Submission #2 to Council of Havelock Belmont Methuen by Ambrose Moran
Re Proposed Zoning Bylaw Amendment (Public Mtg April 14 2009)

Septic Setbacks

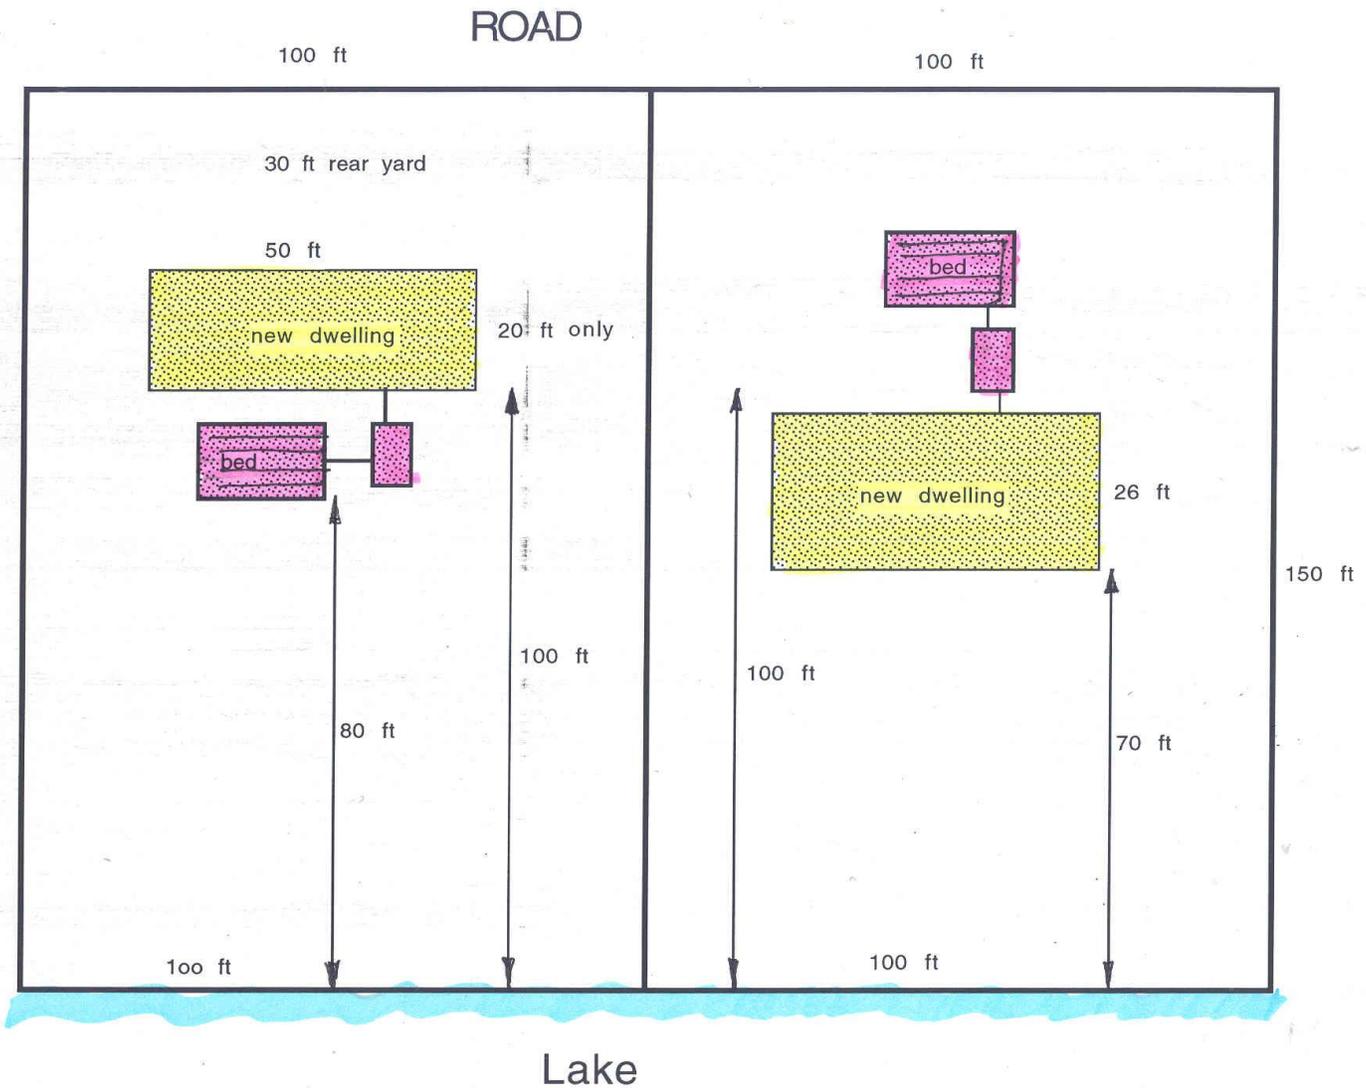
County of Peterborough OPA #3 applicable to the part of Jack Lake in North Kawartha Township is intended to encourage septic systems to meet the 30 meter setback but allows discretion to the Peterborough County Health Unit to continue to approve septic with 50 ft setbacks².

The concept of setting new development back 30 meters from lakes to protect water quality is not achieved in this approach. (Reference dwg attached)
